App. No. 10/501,744  
Amendment dated November 30, 2005  
Reply to Office action of August 31, 2005

**Amendments to the Drawings:**

FIG. 1

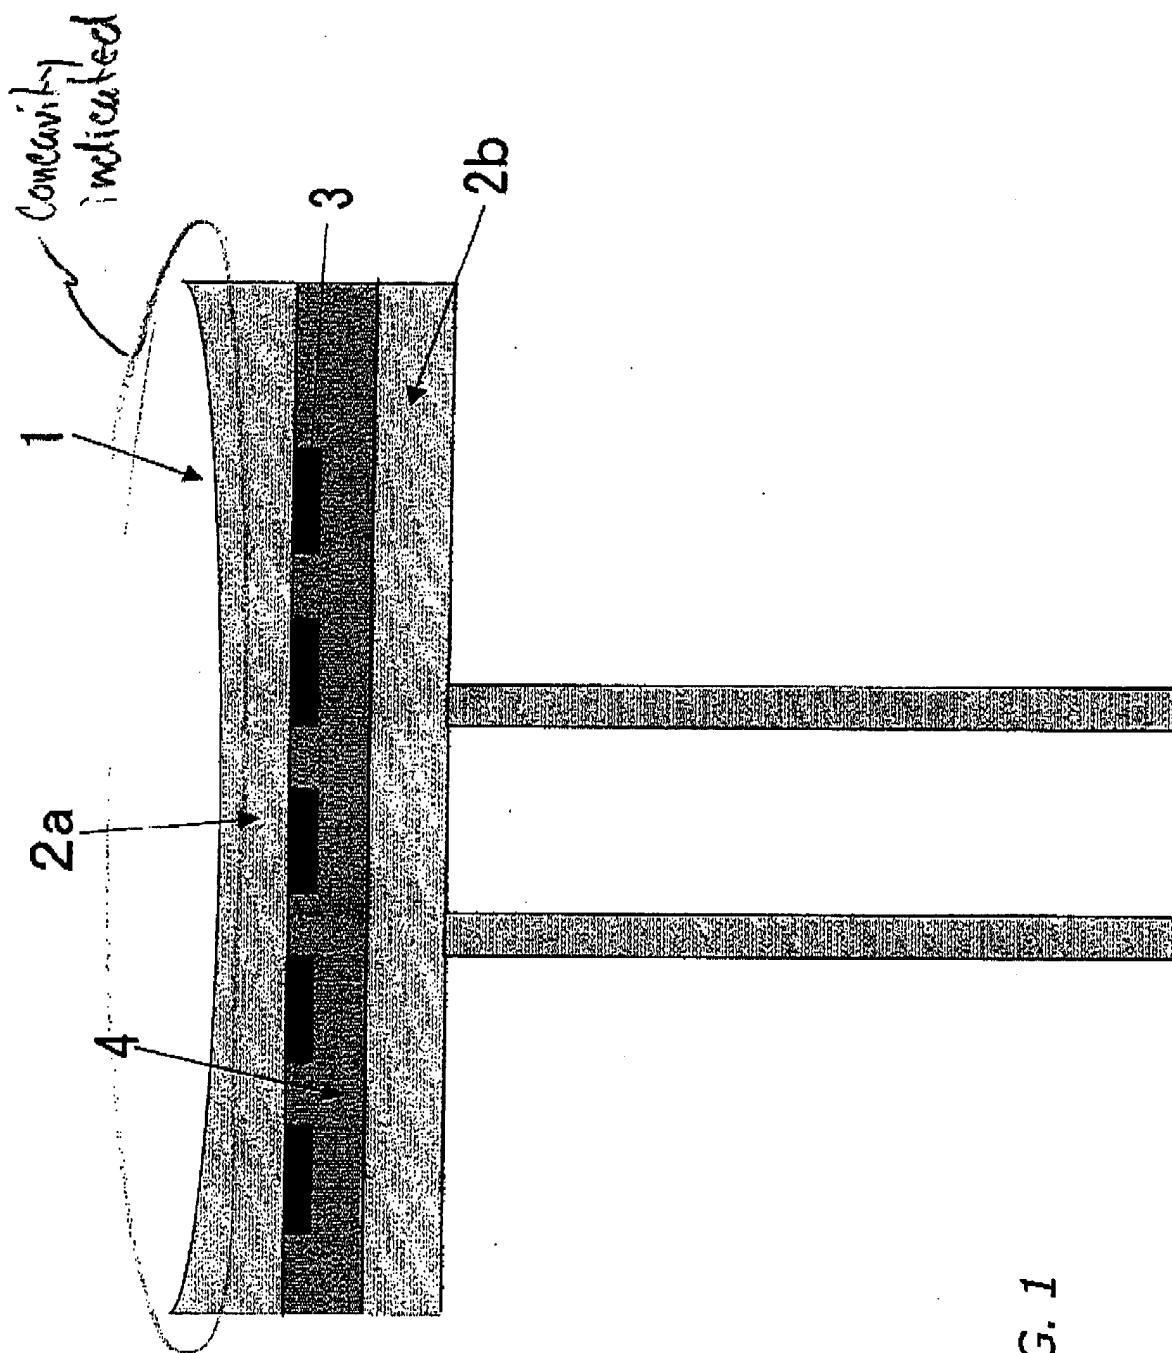
In Figs. 1 and 2, the upper surfaces of the respective susceptors 1 and 11 have been redrawn to represent the concavity therein.

2. The drawings were objected to under 37 CFR 1.83(a). In particular, the Examiner states: "The concavity in claim 1 must be shown or the feature(s) canceled from the claim(s)."

3. Applicants submit corrected drawing sheets herewith in compliance with 37 CFR 1.121(d). Applicants refer the Examiner to new drawing sheets 1/2 and 2/2 including amended Figs. 1 and 2, respectively. Figs. 1 and 2 have been amended to show the concavity of the wafer carrying face and the shaft recited in amended claim 1. Support for these drawing amendments may be found, for example, in Embodiment 1 on pages 6 through 9 of the original specification such that no new matter has been entered. The concavity is supported, for example, by the "warpage" values given in Table 1 (page 9). The concavity is also supported by original claim 1 as well as by numerous other locations in the original specification. The shaft is supported, for example, by the "pipe-shaped support members" disclosed on page 8.
